S6 Use of Steel Grades for Various Hull Members - Ships of 90 m in Length and Above

(1978)
 (Rev.1
 1980)
 (Rev.2
 1996)
 (Rev.3
 May
 2002)
 Rev.4
 July
 2003)
 (Rev.5
 Sept
 2007)
 (Rev.6
 May
 2010)
 (Rev.7
 Apr
 2013)

Fig. 1 Typical deck arrangement for membrane type Liquefied Natural Gas Carriers

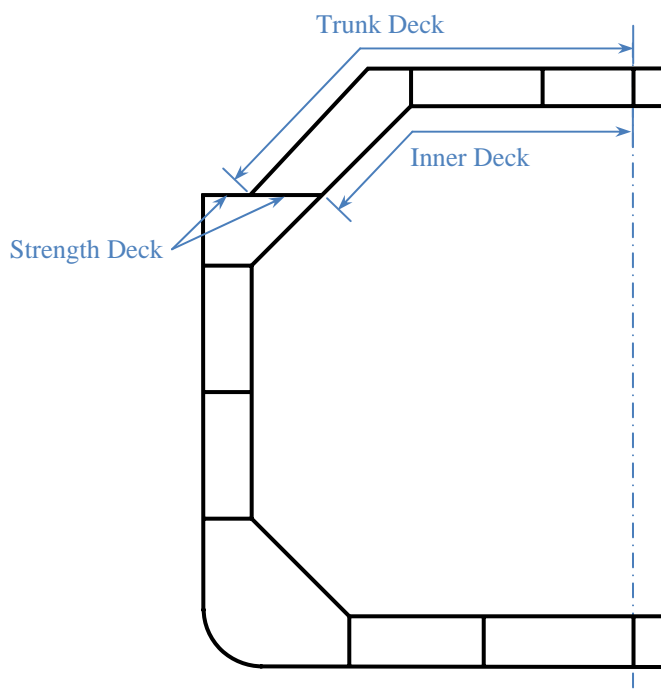
Table 3 - Minimum Material Grades for membrane type liquefied gas carriers with length exceeding 150 m *

(*) Table 3 is applicable to membrane type liquefied gas carriers with deck arrangements as shown in Fig. 1. Table 3 may apply to similar ship types with a "double deck" arrangement above the strength deck.

<u>Structural member category</u>		<u>Material grade</u>
<u>Longitudinal plating of strength deck where contributing to the longitudinal strength</u>		<u>Grade B/AH within 0.4L amidships</u>
<u>Continuous longitudinal plating of strength members above the strength deck</u>	<u>Trunk deck plating</u>	<u>Class II within 0.4L amidships</u>
	<ul style="list-style-type: none"> • <u>Inner deck plating</u> • <u>Longitudinal strength member plating between the trunk deck and inner deck</u> 	<u>Grade B/AH within 0.4L amidships</u>
